PRESERVATION -	ATION SION Wilwaukee Historic Preservation Commission/200 E. Wells Street/Milwaukee, WI 53202/phone 414-286-5712/fax 414-286-3004		
Property	524 W. HISTORIC MITCHELL ST.	Mit	chell Street HD
Description of work	5	uilding to approximately 6' above whe ent shall be 1' taller than the highest p	
Date issued	9/10/2018 PTS II	D 114590 COA: shorten chimney

In accordance with the provisions of Section 320-21 (11) and (12) of the Milwaukee Code of Ordinances, the Milwaukee Historic Preservation Commission has issued a certificate of appropriateness for the work listed above. The work was found to be consistent with preservation guidelines. The following conditions apply to this certificate of appropriateness:

Copies to: Development Center, Ald. Jose Perez, Contractor, Inspector Chris Buzzell (286-2519) 7/25/2018 EAST SCHOOL BLEVATTO JUG_4266.JPG 1669 S. 5th STRAM

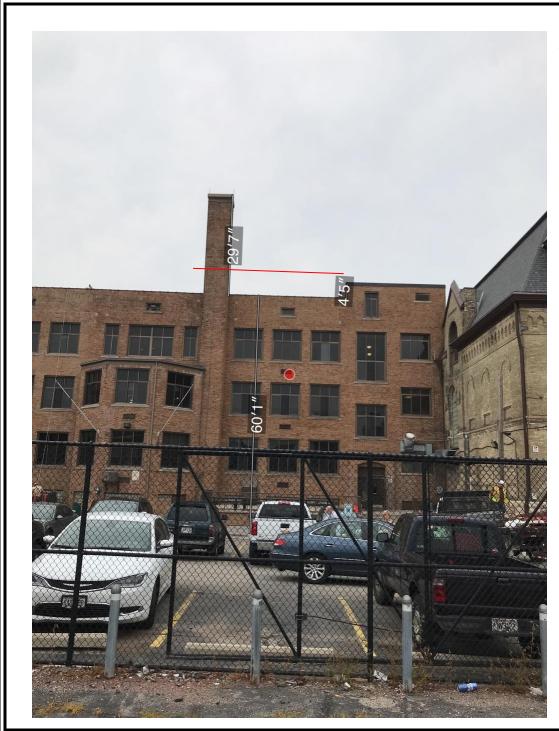
1. Chimney should be at least 1' taller than the tallest portion of the parapet. There is a taller portion of the church side of the school building. This height would be approximately 6' above the parapet at the chimney's location

2. Concrete or other chimney cap should have a slight hipped detail to shed water.

Approximate measurements on rear elevation. Red line shows approximate height of shortened chimney.
